ECLIPSE  
AEROSPACE

## SERVICE BULLETIN

**NUMBER:** SB 500-39-001, REV A  
**MODEL:** ECLIPSE EA500  
**SUBJECT:** WIRE HARNESS INSPECTION AND REPAIR - BATTERY AREA

**Wire Harness Protection  
Figure 2**

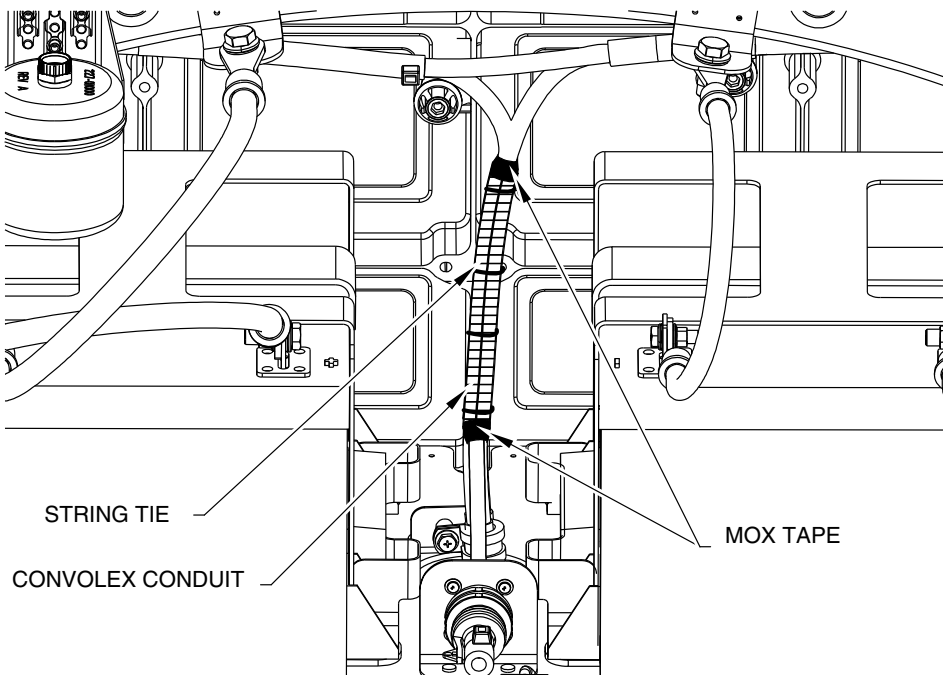
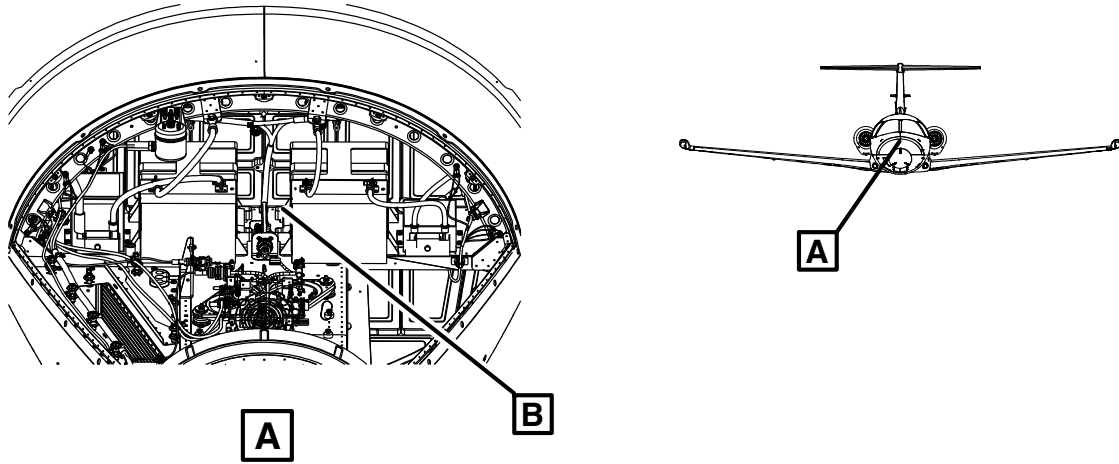
(a) Apply two wraps of Teflon tape centered where the conduit should begin and end. \_\_\_\_\_

(b) Install split Convolex Conduit P/N HCTE-0875 or equivalent as shown in [Figure 2](#). \_\_\_\_\_

NOTE: It is permissible to use a larger diameter of HCTE-( ) Convolex Conduit if repairs were accomplished resulting in increased harness bundle diameter. The size indicated (HCTE-0875-0) is based off of a nominal harness with no repairs. There should be no gap showing where the Convolex Conduit material was split when installed. If a gap is present, a larger diameter should be used.

(c) Wrap Convolex Conduit with Mox Tape at each end and use string tie to secure Mox Tape. Refer to Wiring Repair Manual, para 3.33.1.3. \_\_\_\_\_

(d) Install String Tie every 3 inches of the length of the Convolex Conduit. \_\_\_\_\_

NOTE: Do not over tighten String Tie as to collapse the Convolex Conduit.
